Our Case Number: ABP-317742-23

Re: BusConnects Bray to City Centre Core Bus Corridor Scheme
Bray to Dublin City Centre.

**Expert Report on Issues arising from the proposed BusConnects programme for
the Bray – Dublin City Centre Corridor**

Professor Austin Smyth

Diagram 6.6: Weighted Average People Movement by Mode During 2028 AM Peak Hour

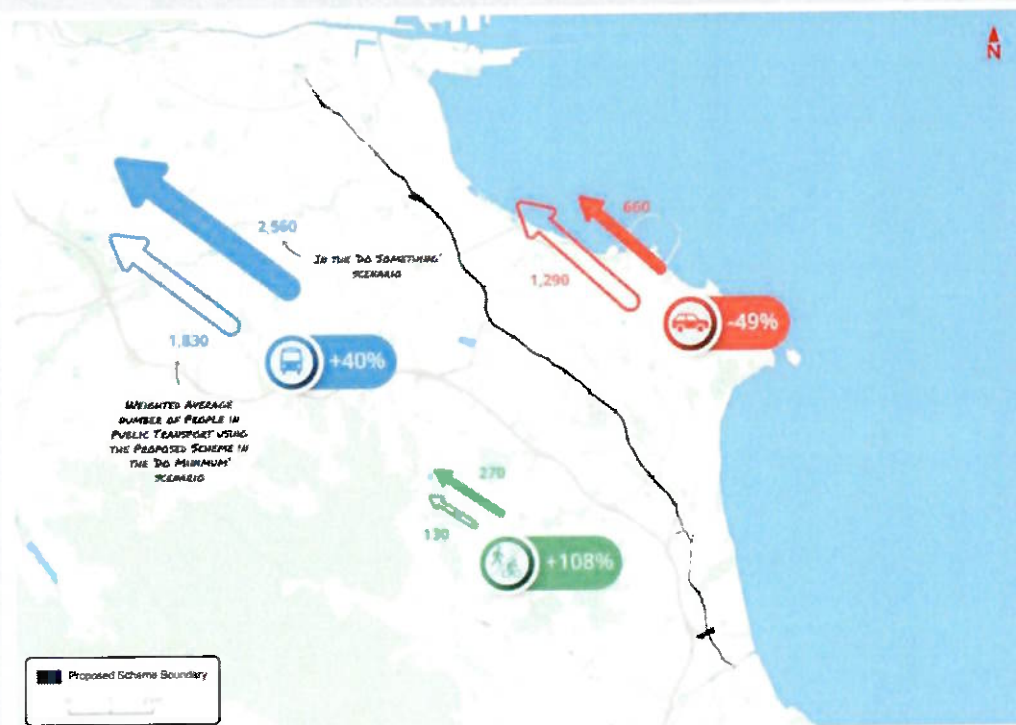
As indicated in Diagram 6.6, there is a reduction of 49% in the number of people travelling via car, an increase of 40% in the number of people travelling via bus and an increase of 108% in people walking or cycling along the Proposed Scheme during the AM Peak Hour.

The projections of very large modal shifts set out above pose important questions concerning the robustness of the forecasts generated by the forecasting tools employed. Addressing questions about the robustness of these projections would require in-depth review of the validation performance of the models, as well as application of realism testing and sensitivity testing.
